REFERENCE: P2022/0588
DESCRIPTION: Proposed conversion of existing building from Offices (Class A2) into 7 self-contained residential units comprising: 2 No studio, 3 No 1 bed and 2 No 2 bed, three and single storey rear extension and demolition of existing detached storage to rear and construction of detached two storey building comprising: 2 No 2 bed residential units at the rear of main building together with associated works.
LOCATION: NEATH CARE, 96 GNOLL PARK ROAD, NEATH, SA11 3DD
DECISION DATE: 8th July 2022
CASE OFFICER: M. Rhodri Griffiths – r.griffiths2@npt.gov.uk

Discharging Condition 13

Observe Glazing Within Internal Courtyard

96 Gnoil Park Road, SA11 3DD

Figure 1: Locations of Obscure Glazing
Refer to drwgs: DC-13A revA & DC-13B revA

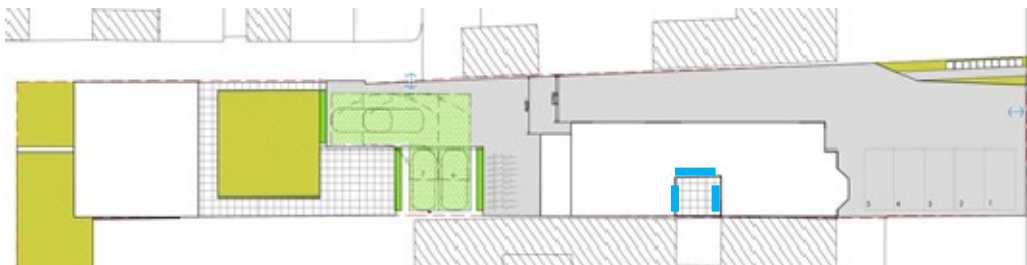
Before the development hereby permitted is brought into use, an obscure glazing scheme for all windows facing the internal courtyard shall first be submitted to and agreed in writing by the local planning authority. Any part of the window[s] that is less than 1.7m above the floor of the room in which it is installed shall be non-opening. The windows shall be permanently retained in the approved condition thereafter.

Obscure glazing for all windows that face the internal courtyard will be installed. Any part of the window[s] that is/are less than 1.7m above the floor of the room in which it is installed shall be non-opening.

The accompanying drawings, DC-013A and DC-013B, showing the internal facing courtyard windows having obscure glazing and non-openable as requested below 1.7m.
